LATERAL 11, MAIN 19 OF THE SOUTHWEST INTERCEPTOR SEWER

OCA NO. 744118
CITY OF WICHITA PROJECT NO. 468-83691

As-Built

RECORD DRAWING

SANITARY SEWER LINE NO. 1

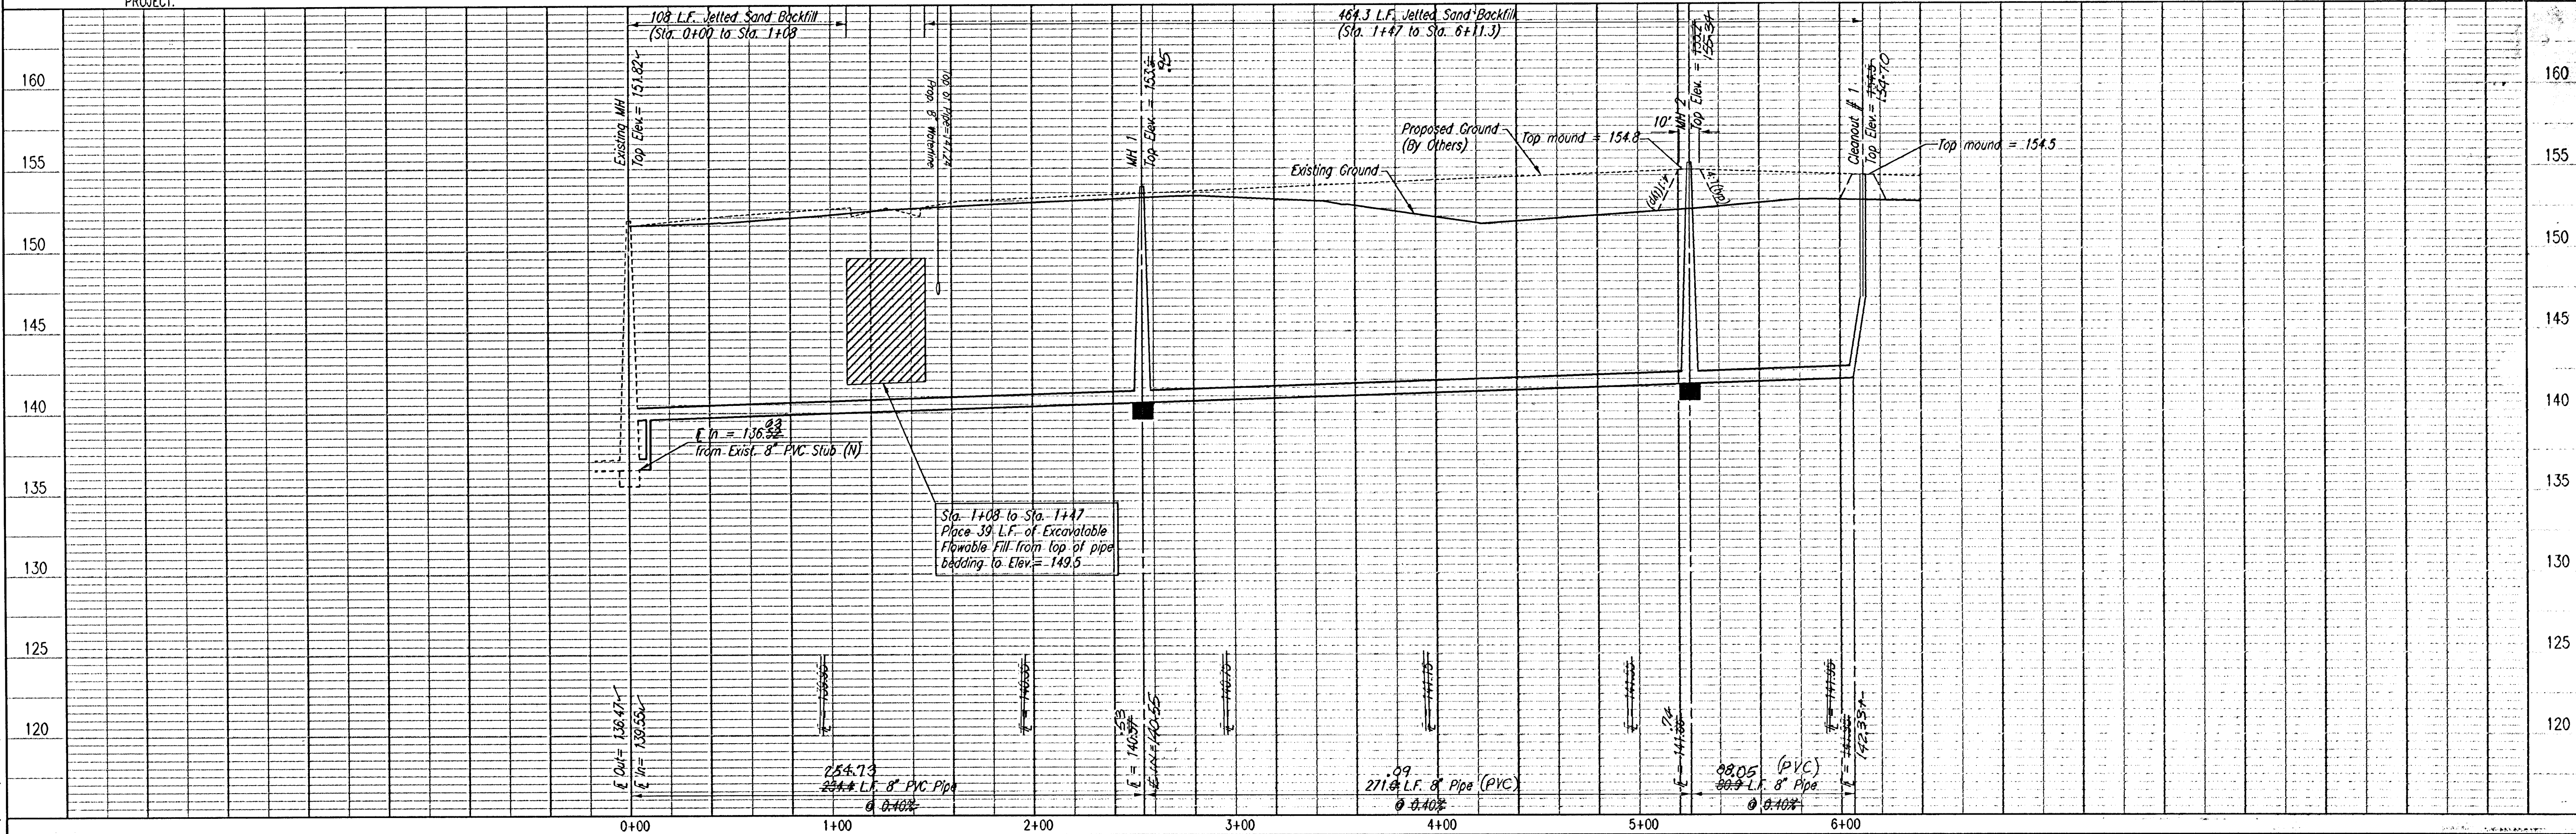
.4485 .3965
 N-11,060.2466, E-12,515.7753
 Sta. ~~2+54.4~~ 2+54.73
 Const. MH 1
 Standard MH (Type 'p')

N-11,331.2403, E-12,515.3296
Sta. ~~5+25.4~~ 5+25.82
Const. MH 2
Standard MH (Type 'P')

418.8894 .0840
N-11, ~~416.4436~~; E-12, ~~504.6628~~
Sta. ~~6+11.3~~ 6+13.87
Construct Cleanout #1
See detail, sheet no. 9

SANITARY SEWER PIPE SLOPES HAVE NOT BEEN REVISED TO REFLECT AS CONSTRUCTED CONDITIONS.
